FORM APPROVED OMB NO. 1004-0135 Expires: July 31, 2010 UNITED STATES DEPARTMENT OF THE INTERCATISDAD FIELD BUREAU OF LAND MANAGEMENT

a t	. תפי אנ	Secondar A	Lease Senal No
SUNDRY NOTICES AND REPOR	TS ON WELLS		THESIM	NMNM2923

1. Type of Well		8. Well Name and No.				
☑ Oil Well ☐ Gas Well ☐ Oth		ERAL 12 14H				
Name of Operator OXY USA INCORPORATED		9. APJ Well No. 30-015-40821-00-S1				
3a. Address 5 GREENWAY PLAZA STE 1 HOUSTON, TX 77046-0521	Phone No. (include area code: 713-513-6640		10. Field and Pool, or Exploratory WILDCAT

CONDITIONS OF APPROVAL TO INSTALL VAPOR COMBUSTOR UNIT (VCU)

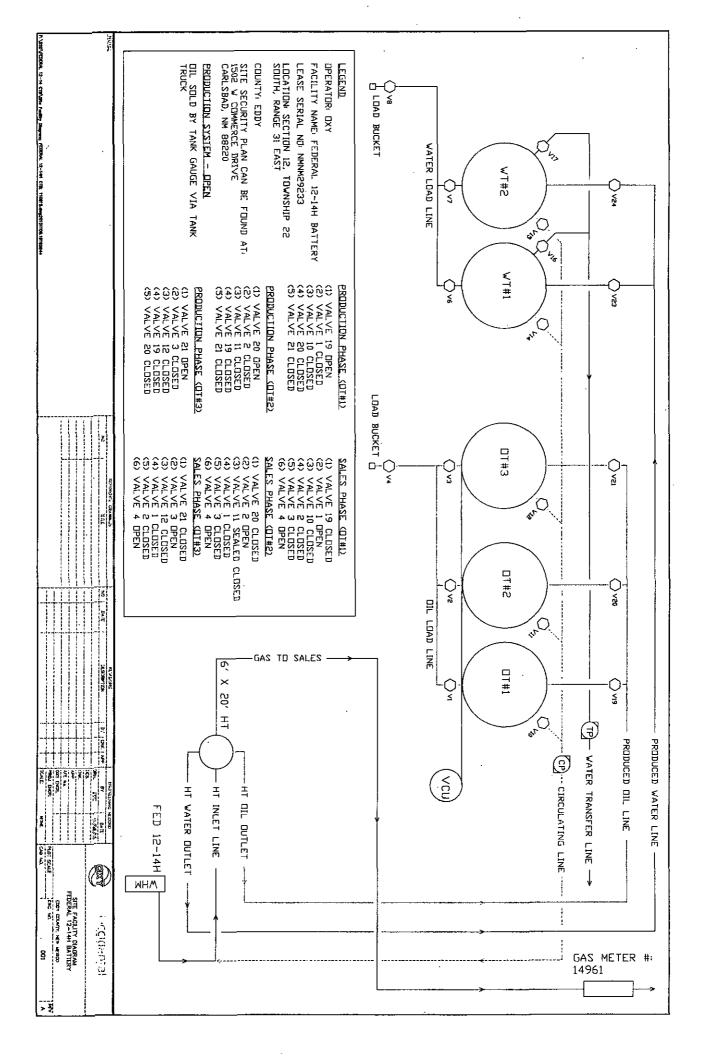
5. Per 43 CFR 3162.7-5(d)/Onshore Order No.3.III.1.1, site facility diagram must be submitted within 60 days of equipment installation.
